VALUE ENGINEERING REPORT

I-985 / SR 11 Interchange Reconstruction
NH-985-1(340), PI No 110465
Hall County

February 4, 2008

MACTEC Engineering and Consulting, Inc.
3200 Town Point Drive NW, Suite 100
Kennesaw, GA 30144

ITEM N^o: A-5
CLIENT: GDOT
Sheet 3 of 5

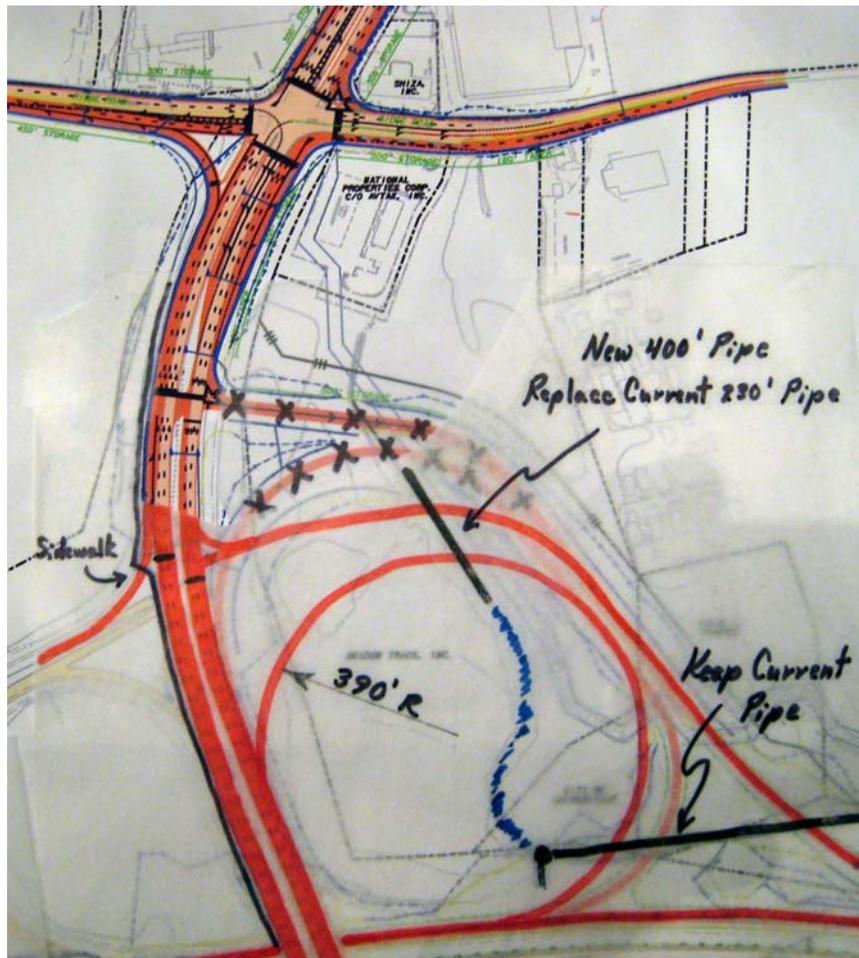
The current design proposes an intersection separation of approximately 600 feet between Ridge Road and the SB I-985 Off-Ramp connection to SR 11. This condition results in an extremely short weave distance for SB Ridge Road traffic (dual left) wanting to enter the SB I-985 On-Ramp and traffic from the free NB Ridge Road right turn lane to eastbound SR 11 or the SB I-985 On-Ramp. This minimal separation is caused by the use of a large (800 ft x 1,100 ft) oval loop ramp for the EB SR 11 to SB I-985 connection. The large oval loop ramp was developed to shift the ramp away from a small stream the runs through the quadrant, however, it results in the taking of a small wetland area on the west side of the Meadow Trace property (already acquired). This design also includes an unprotected sidewalk crossing of the free-flowing SB I-985 On-Ramp approximately 350 feet west of the signalized SR 11 / SB I-985 Off-Ramp intersection.

It is recommended that the SB I-985 Off-Ramp connection to SR 11 be moved approximately 350 feet east to align up with the SB I-985 On-Ramp. This recommendation also requires the large oval loop ramp for EB SR 11 to SB I-985 traffic to be reduced to a circular ramp with a 750 to 800-foot diameter. Spreading out this intersection to approximately 950 feet would increase the SR 11 westbound weave distance by 35 percent and give more storage space for the eastbound SR 11 turn lanes at Ridge Road.

- The additional intersection separation will significantly improve the weave condition for the SB Ridge Road (double left) traffic entering the SB I-985 On-Ramp and the overall operation of the two closely spaced signalized intersections. (Current spacing is about 600 feet.)

- The recommended concept would align the SB I-985 Off-Ramp and the SB I-985 On-Ramp across from each other at the same signalized intersection.
- This concept shifts the signalized intersection to the SB I-985 On-Ramp gore area where pedestrian signals can be installed at the south sidewalk / free flow I-985 On-Ramp crossing. Signalizing the sidewalk / ramp crossing would improve pedestrian safety and reduce the crossing liability.

- The use of a large circular loop ramp in-lieu-of the large oval loop ramp would provide similar environmental protections for the small stream, such as; places much of the ramp north of the stream, allows the stream to remain open in the center of the ramp, and uses about the same amount of enclosed storm pipe. The smaller footprint of the recommended concept would reduce the area of overall impacts.

Current Design (Approximately 600 Feet of Separation)

Recommended Design (Approximately 950 Feet of Separation)

ITEM N^o: A-7 & I-1
CLIENT: GDOT
Sheet 2 of 4

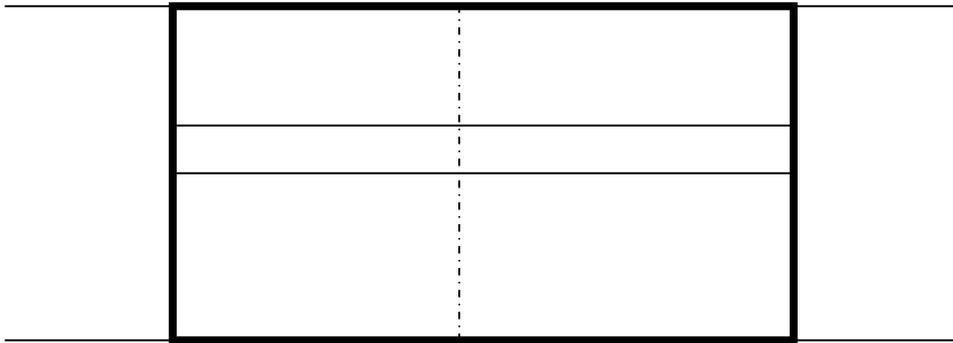
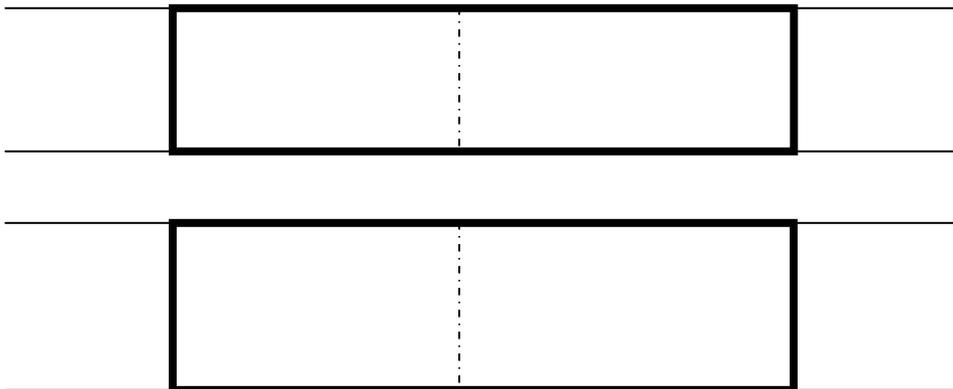
The current roadway design for SR 11, Ridge Road, and Monroe Drive includes 12-foot lane widths throughout the entire project. The current design concept widens both existing structures to the inside and outside, and would close the median area by constructing a 16'-0" raised concrete median. The total bridge width required in the current design is 136'-10." The existing structures are 2-span (120'-141') structural steel continuous unit bridges.

It is recommended that the width of the travel lanes on SR 11, Ridge Road, and Monroe Drive be reduced from 12 feet to 11 feet. It is further recommended that all turn and merge lane widths be kept at the proposed 12-foot width. This concept would keep two separate bridges with an open median (Eastbound - three traffic lanes plus a sidewalk [45'-10"] and Westbound - four traffic lanes with no sidewalk [51'-3"]).

Reducing the width of the travel lanes from 12 feet to 11 feet would result in a significant cost savings to the project. Changing to 11-foot lane widths on SR 11 would reduce the amount of bridge widening needed on the two existing long bridges crossing I-985. In addition, reducing the width of the median side bridge widening increases the distance between the two bridges, further suggesting that the median area between the bridges remain open (current design would construct a raised concrete median between the dual structures). Leaving the dual bridges with an open median results in additional cost and time savings to the project. The 11-foot through lanes would accommodate the project traffic and provide adequate safety for this urban roadway with a posted speed of 45 MPH.

**Current Bridge Design Concept (12-foot lanes):
Widen existing two structures and close median
Singed 136'-10" x 261' Bridge**

**VE Recommended Design (11-foot lanes):
Widen existing structures and leave median open
1 @ 45'-10" x 261' and 1 @ 51'-3" x 261'**

ITEM N^o: A-7 & I-1
CLIENT: GDOT
Sheet 2 of 4

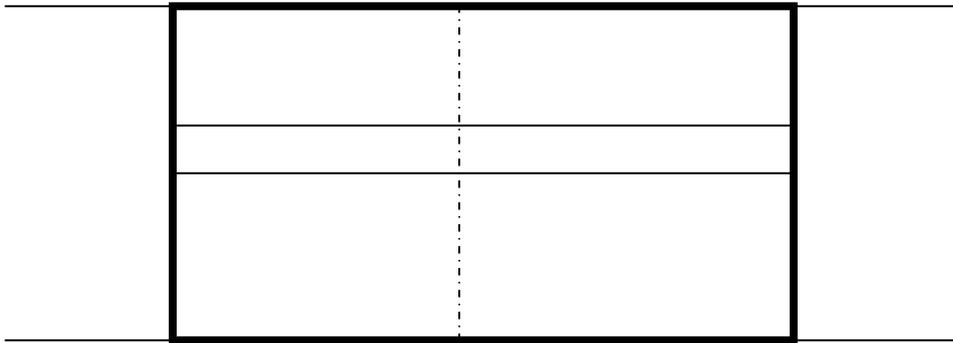
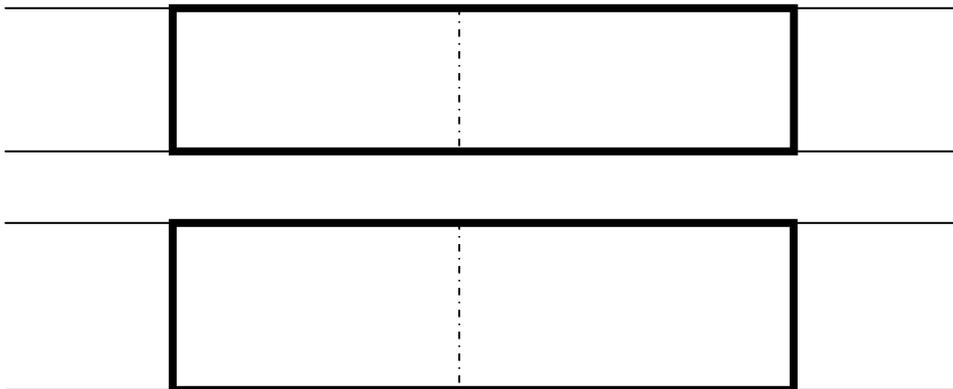
The current design concept is to widen the existing SR 11 bridges and to tie them together by constructing a 16'-0" raised concrete median between the structures. This would result in a single bridge width of 136'-10". The existing bridges are 2-span (120' – 141') structural steel continuous unit bridges.

It is recommended that the proposed 16-foot raised median tying the two SR 11 structures together be eliminated, thereby leaving two separate structures in place. The eastbound bridge should be widened (48' -10") enough to accommodate three traffic lanes and a sidewalk. The westbound bridge should be widened (55' -3") enough to accommodate four traffic lanes with no sidewalks.

There are no turn lanes on these bridges so there is no need to construct the 16-foot raised median between the structures. Eliminating the median does not impact the basic function of the bridges. The elimination of 16-foot median will result in a significant cost savings. This concept would also reduce construction time and simplify construction.

**Current Bridge Design Concept (12-foot lanes):
Widen existing two structures and close median
Singled 136'-10" x 261' Bridge**

**VE Recommended Design (12-foot lanes):
Widen existing structures and leave median open
1 @ 48'-10" x 261' and 1 @ 55'-3" x 261'**
